RE: NBHS - BG 24-192 - Change Order 29 - Added Concrete Paving and Storm Drainage at Bullitt Central High School

Change Order

CHANGE ORDER INFORMATION:
Change Order Number: 029
Date: 12-15-2025

Change Order Request 45 - PCO #99 - BCHS Baseball Drainage Fix

MATCHLINE - SEE DRAINAGE AND UTILITIES PLAN (C1.24 BCHS)

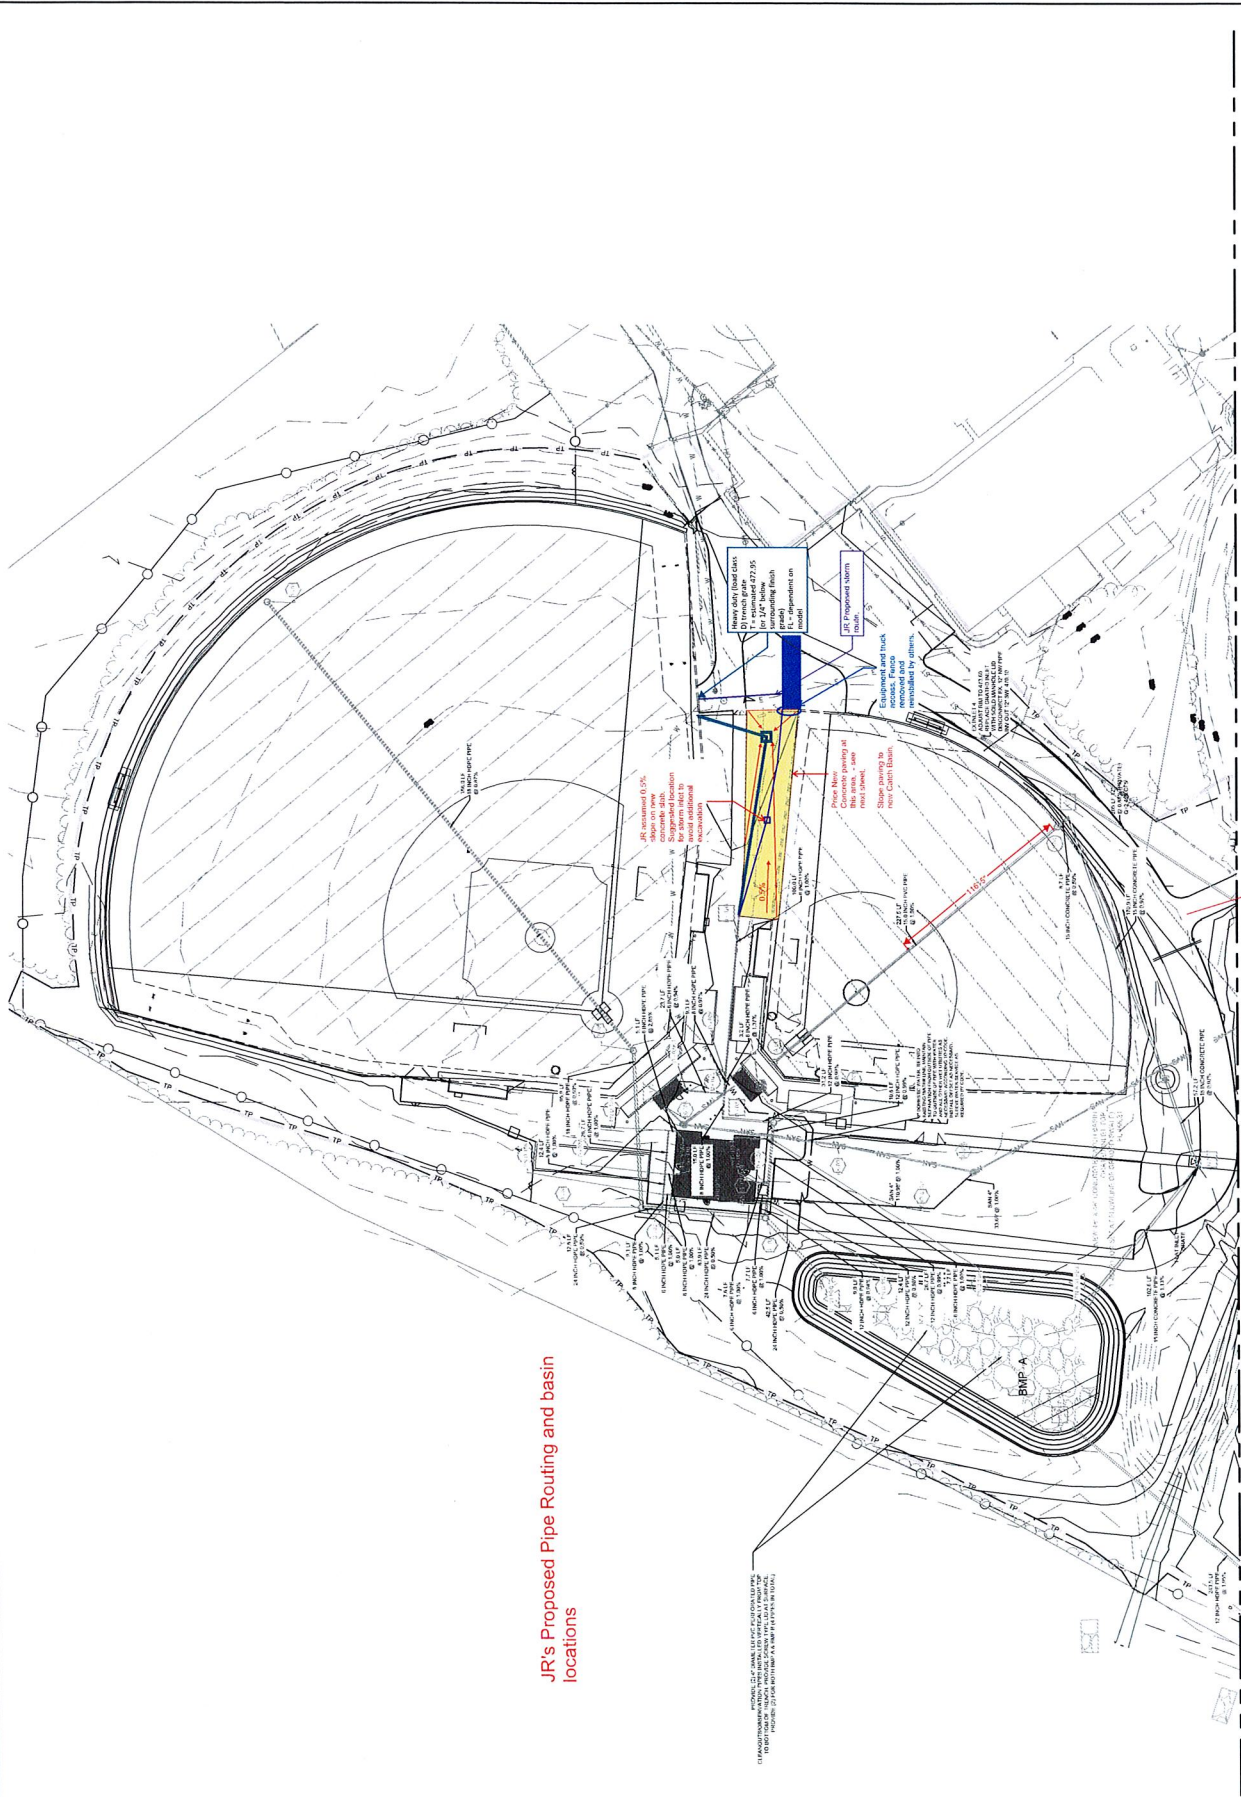
JR Contracting
Bullitt Central - Basball drainage issue at ambulance access
Cost Summary

Stone base below concrete
Fence removal and replacement
Any work associated with existing flagpole
Concrete slab around trench drain
Permits and MOT
Dirt subgraded graded to +/- 0.1'

CCS Unit Price Add:
\$7,140.00

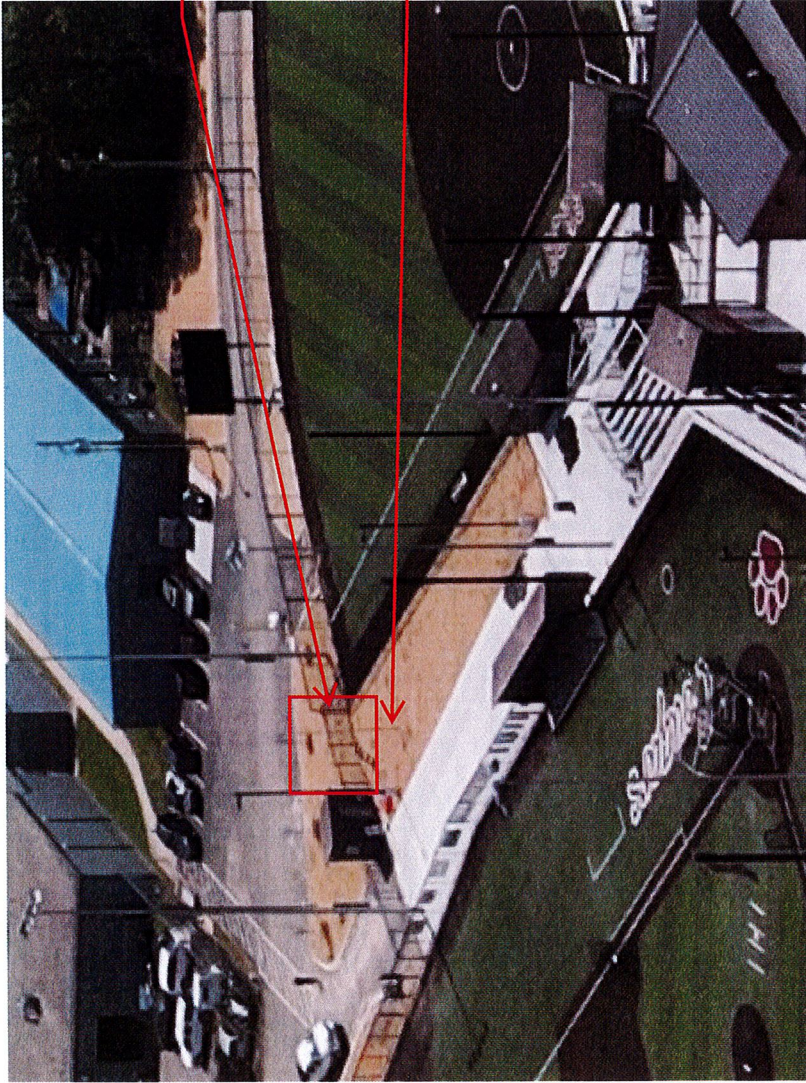
Remove/Reinstall
chain link fencing

No work included at
existing flag pole;
remains in place
